Amendments to ECE/TRANS/WP.29/GRE/2014/7

I. Proposal

"1. Front position lamps

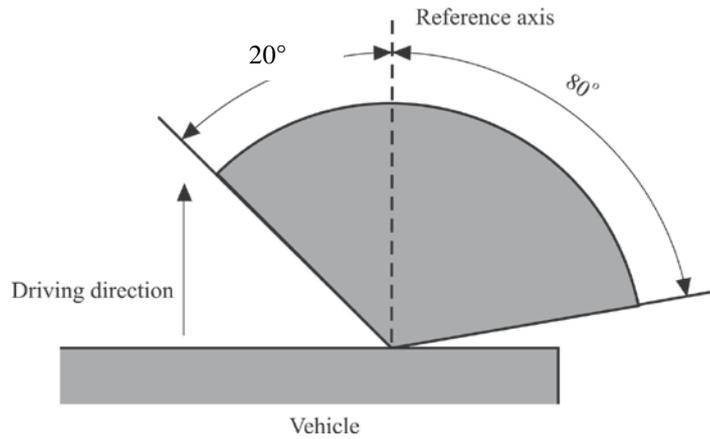
Annex 1, paragraph 1., at the end of the proposed text insert the missing diagram:

(Insert the following missing diagram showing the visibility of angles)

$V = +15^\circ / -10^\circ$

However, in the case where a device is intended to be installed with its H plane at a mounting height less than 750 mm above the ground, the angle of 10° below the horizontal may be reduced to 5° .

"Annex 3

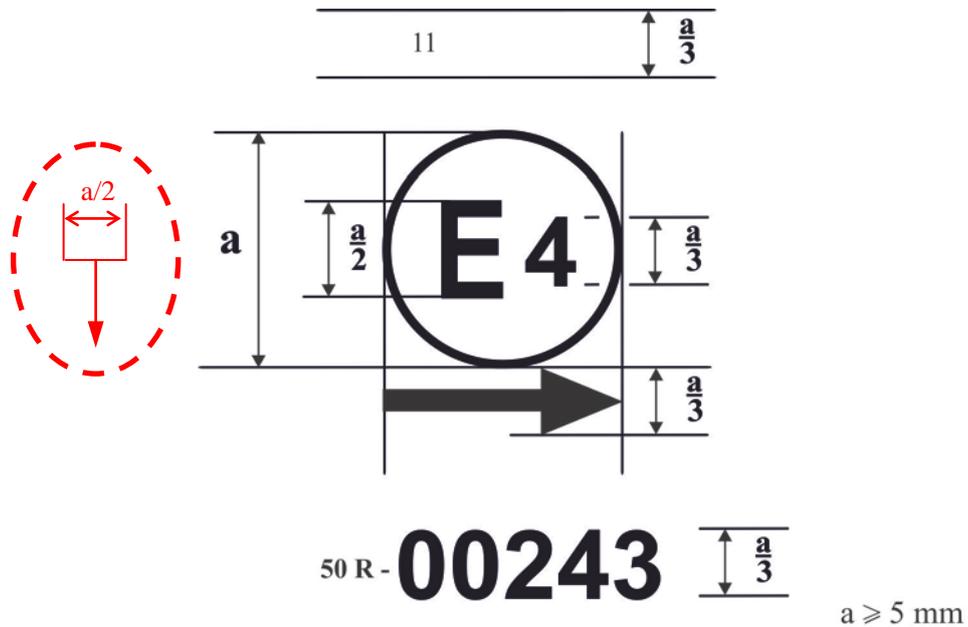
Annex 3, correctly highlight the marking clause for the interdependent lamps:

Interdependent lamps

12 MRY MSY

R50-00113

Marking of an interdependent lamp comprising part of an interdependent lamp system providing:
